PLANNING REPORT – AMENDMENT TO APPROVED PLAN

Lafayette Street Amended Subdivision (Re: 474 Lafayette Street)

Plan Amendment Staff Review: April 10, 2020

Revised Plan (Excerpt) Showing Land Exchange Areas

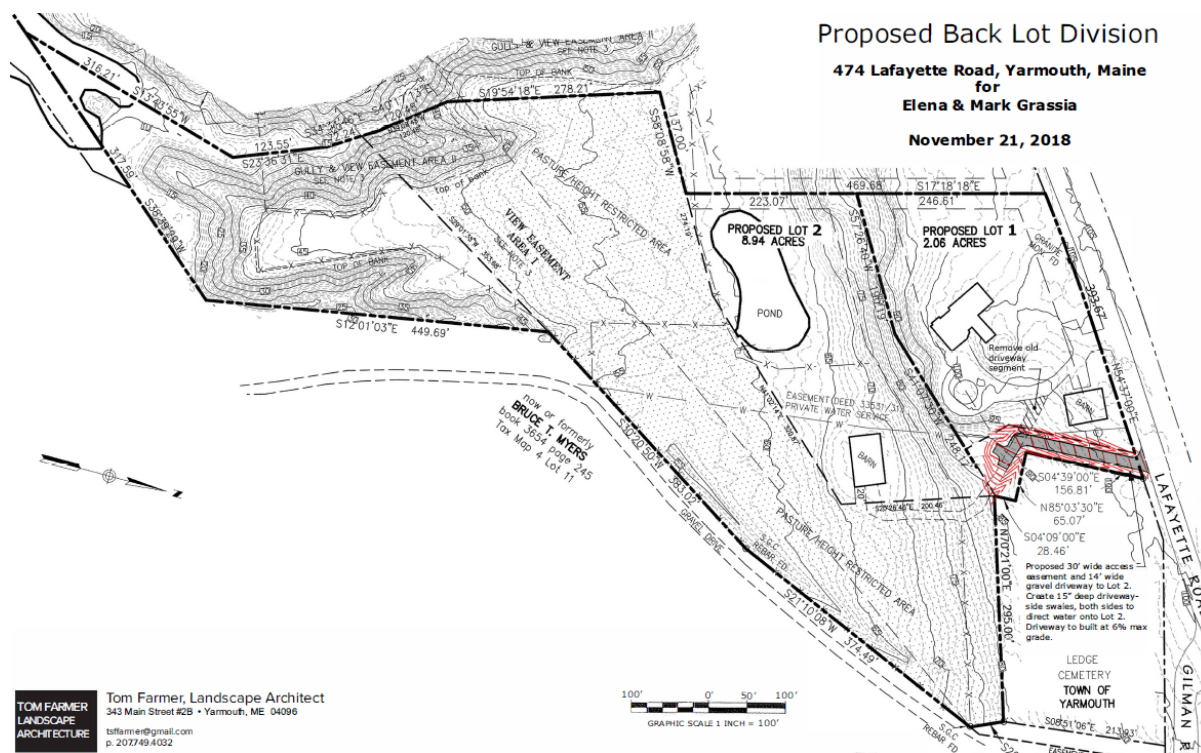
On March 6, 2020, Pamela Higgins and Stephen Connolly applied for an amendment to the approved subdivision to reconfigure the back lot (Map 4 Lot 12-A1) to acquire the land fronting Lafayette Street over which they have an access and utility easement, and convey an equal amount of land to the front lot (Map 4 Lot 12-A). The purpose of this land exchange is to provide the Higgins/Connolly lot with street frontage on Lafayette, which will enable them to provide public water to their home via a service line (1 ½” – 2”) instead of larger water main (8”). Also included in the revised plan is a redesign of proposed driveway to the back lot to soften the grades and reduce the amount of fill required to construct the driveway.

The new lot configuration shows 65' of frontage on Lafayette Street, as required for a service line.
